LAND USE APPLICATION COMPLETENESS REVIEW

Second Review Comments

Subject Property: 1105 Front Street NE

Reference Nos.: 24-106451-PLN (Class 3 Site Plan Review, Tentative Subdivision Plan, Class 1 & 2 Adjustment, Class 2 Driveway Approach Permit)

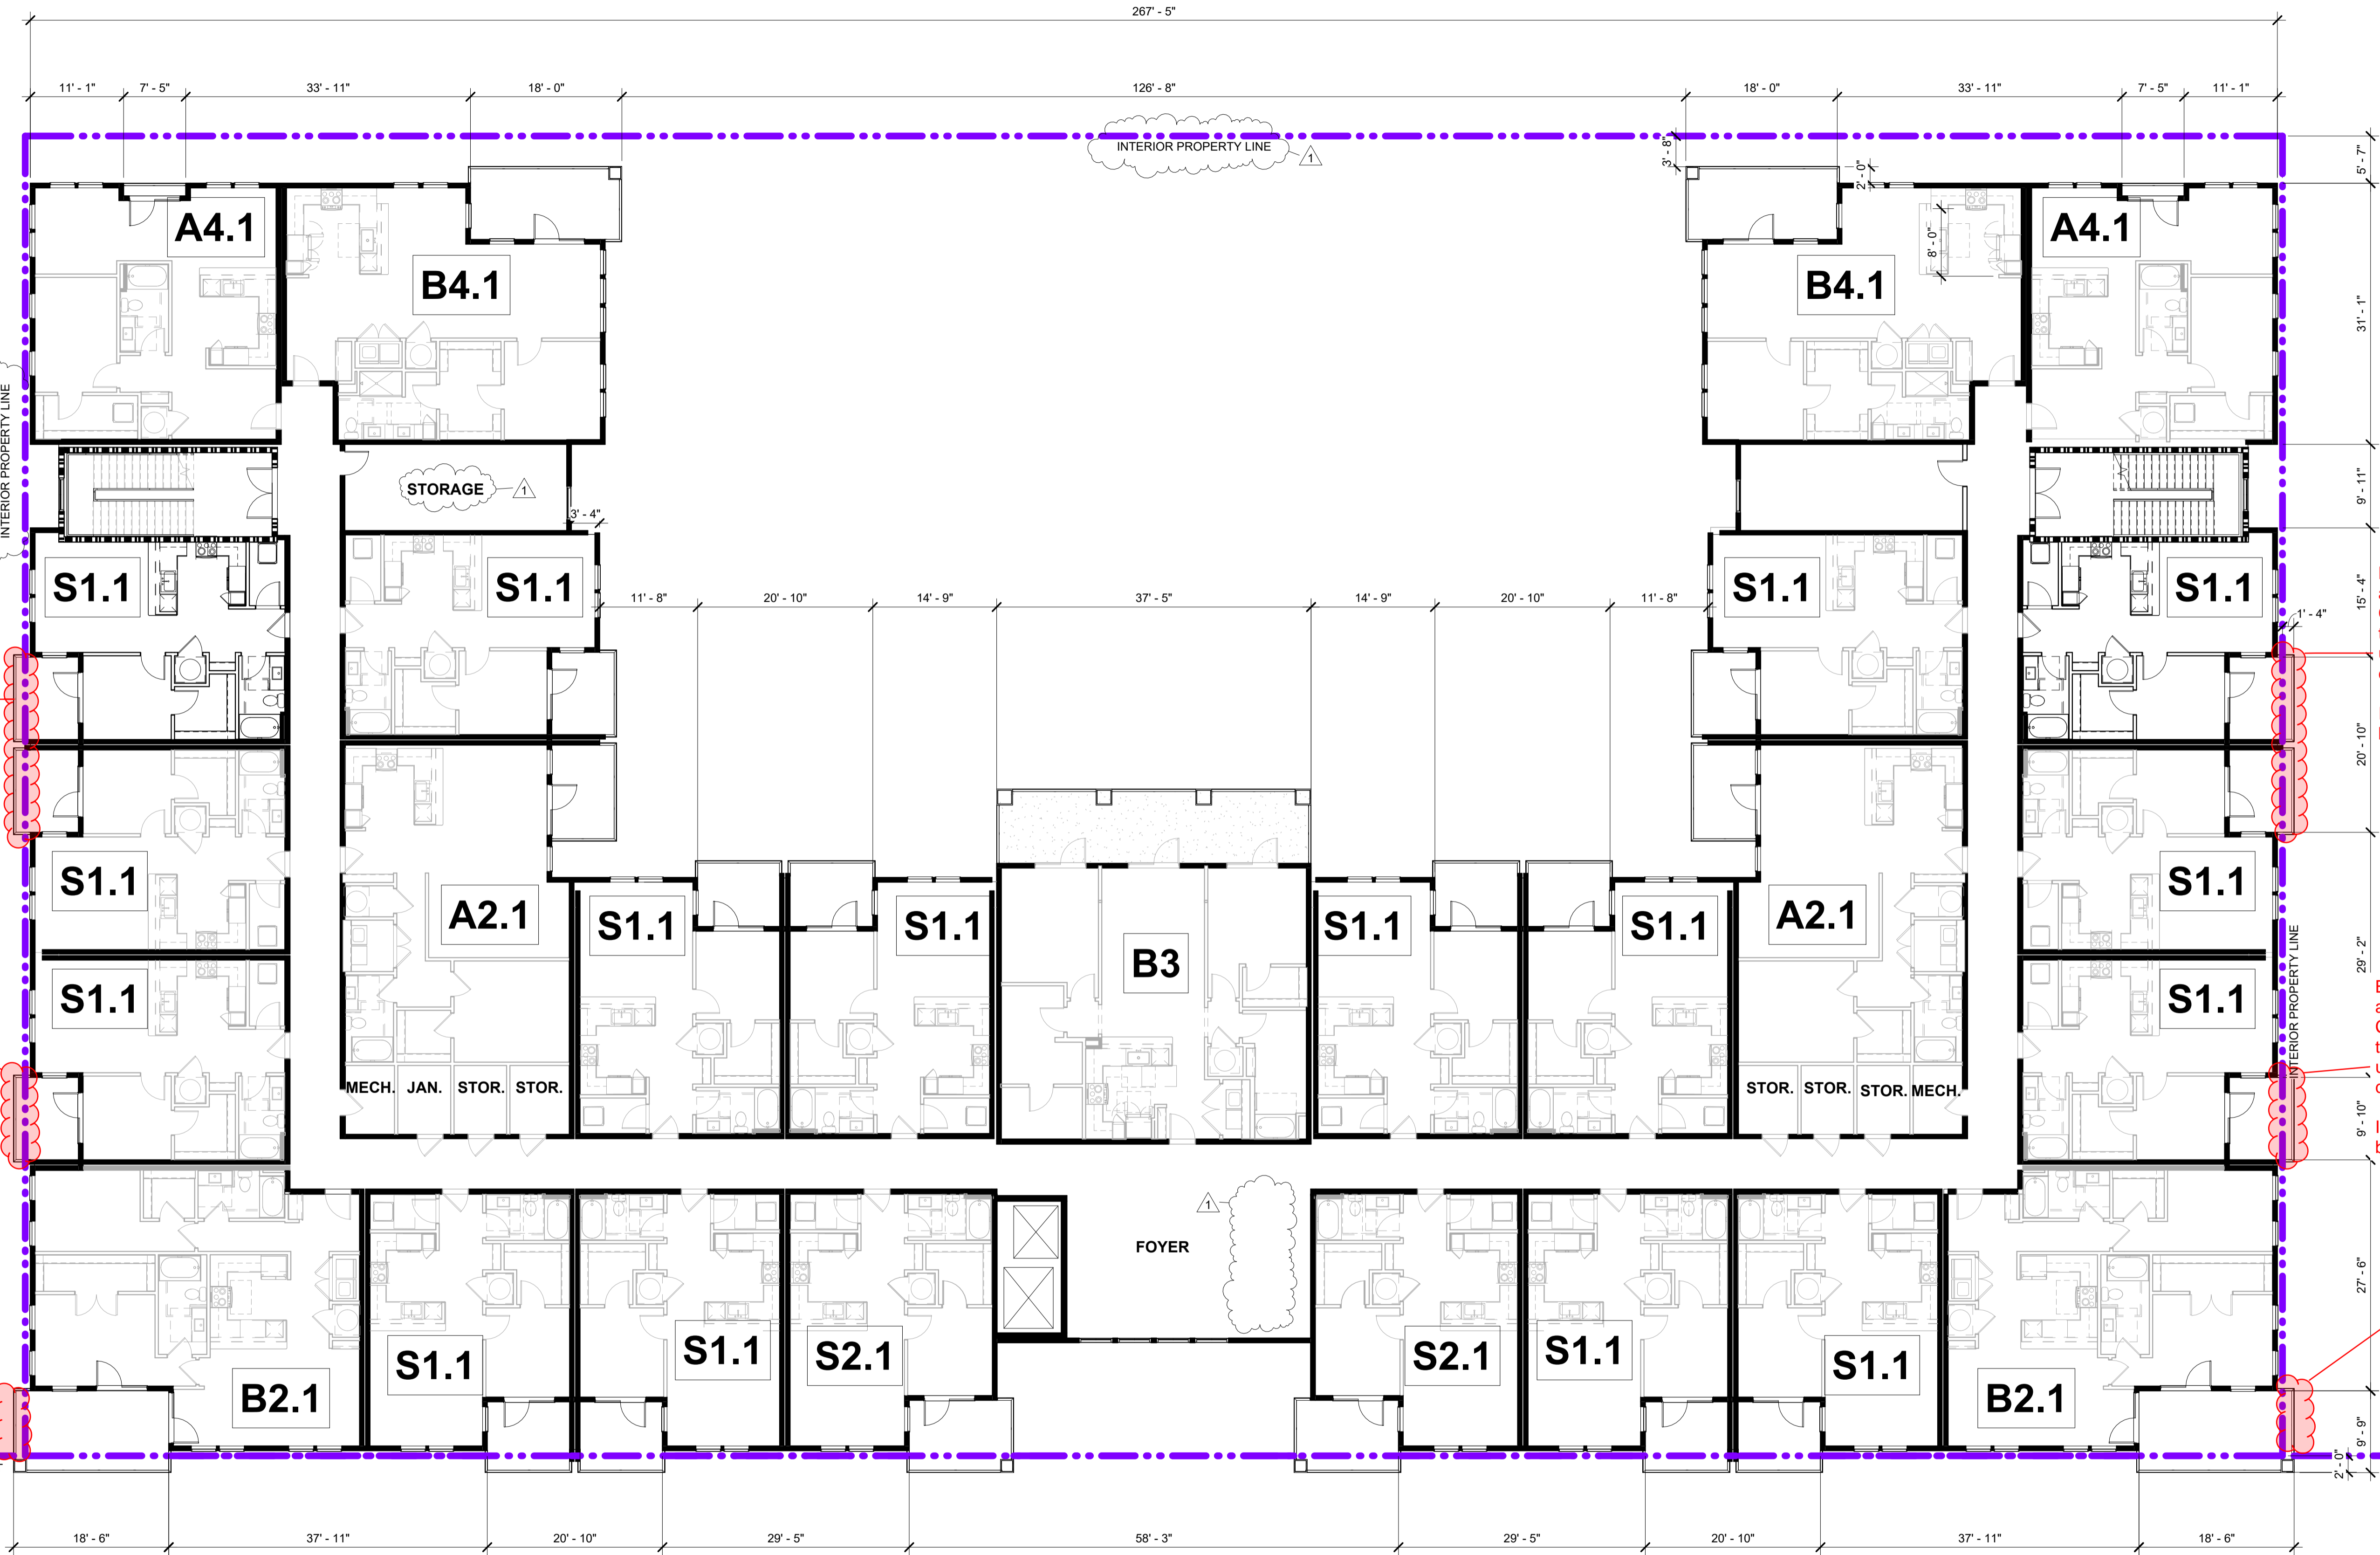
Balconies project across property line. Confirmation required if this will be allowed under the building code.
If so, an easement will be required.

Balcony projects across property line. Confirmation required if this will be allowed under the building code.
If so, an easement will be required.

Balcony projects across property line. Confirmation required if this will be allowed under the building code.
If so, an easement will be required.

Balconies project across property line. Confirmation required if this will be allowed under the building code.
If so, an easement will be required.

Balcony projects across property line. Confirmation required if this will be allowed under the building code.
If so, an easement will be required.

Balcony projects across property line. Confirmation required if this will be allowed under the building code.
If so, an easement will be required.

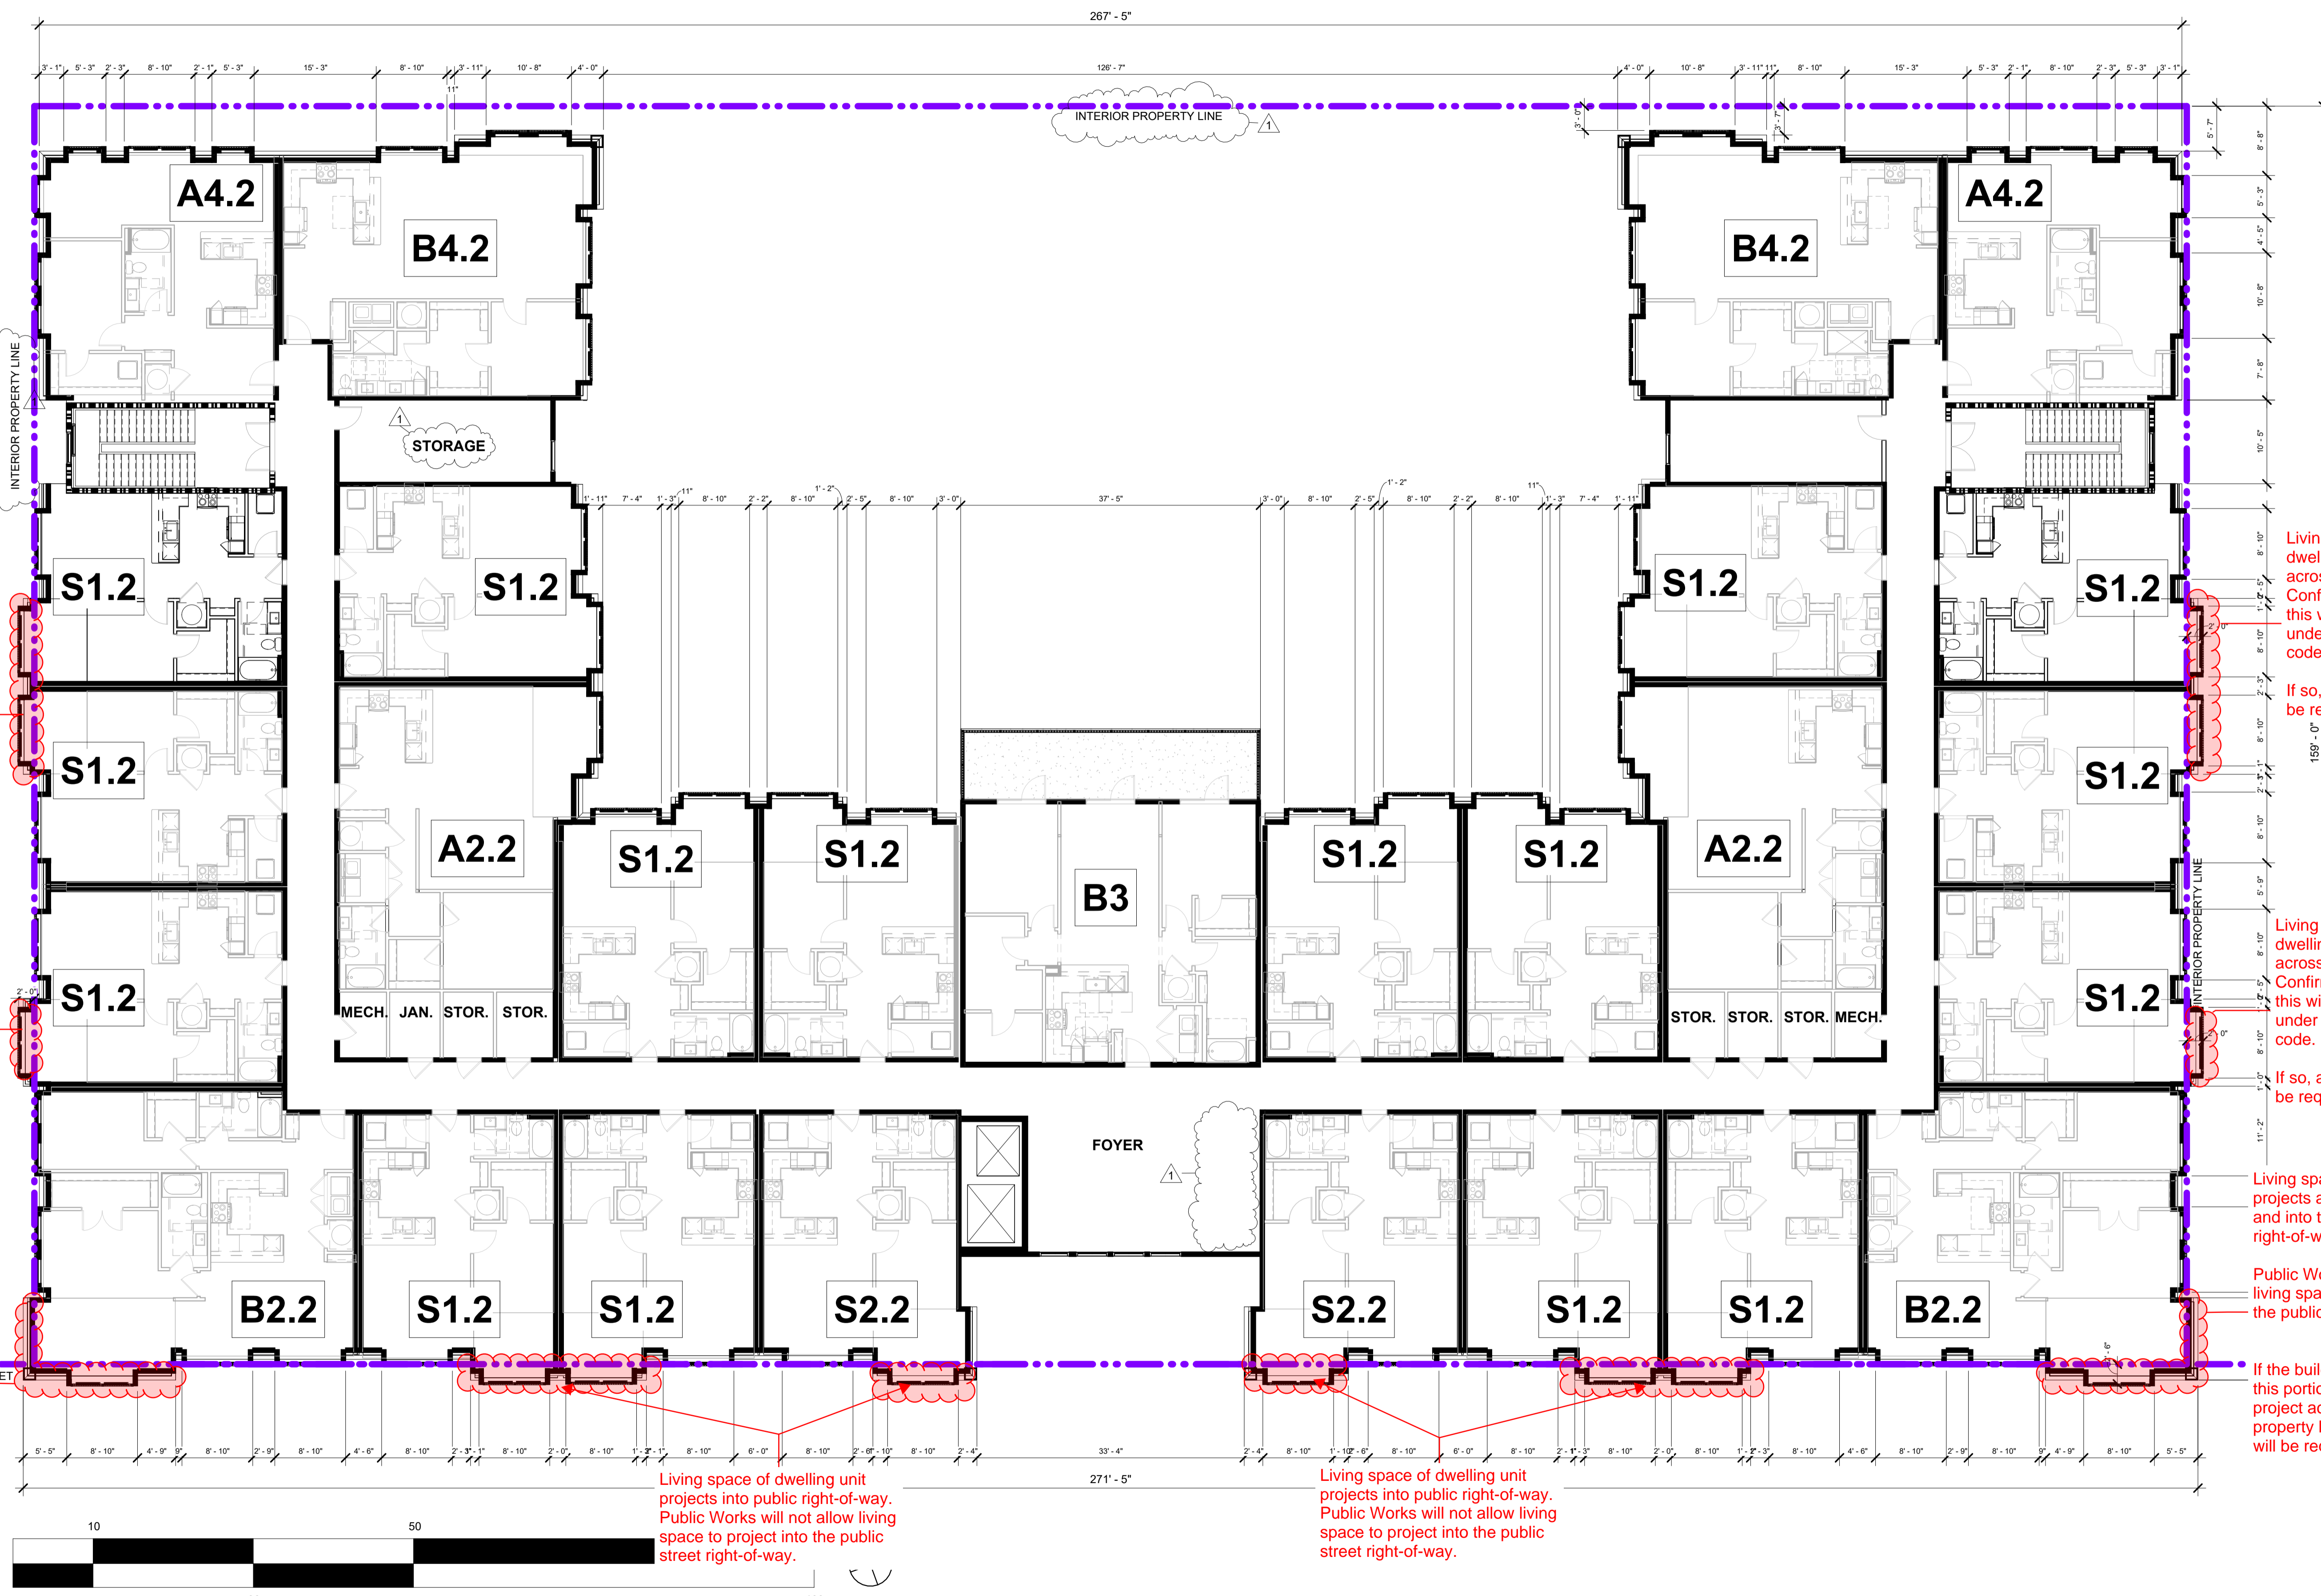
Living space of dwelling units project across property line. Confirmation required if this will be allowed under the building code.

If so, an easement will be required.

Living space of dwelling unit projects across property line. Confirmation required if this will be allowed under the building code.

If so, an easement will be required.

Living space of dwelling unit projects across property line and into the public street right-of-way.

Public Works will not allow living space to project into the public street right-of-way.

If the building code will allow this portion of the building to project across the south property line, an easement will be required.

Living space of dwelling unit projects into public right-of-way. Public Works will not allow living space to project into the public street right-of-way.

Living space of dwelling unit projects into public right-of-way. Public Works will not allow living space to project into the public street right-of-way.

Living space of dwelling units project across property line. Confirmation required if this will be allowed under the building code.

If so, an easement will be required.

Living space of dwelling unit projects across property line. Confirmation required if this will be allowed under the building code.

If so, an easement will be required.

Living space of dwelling unit projects across property line and into the public street right-of-way.

Public Works will not allow living space to project into the public street right-of-way.

If the building code will allow this portion of the building to project across the north property line, an easement will be required.
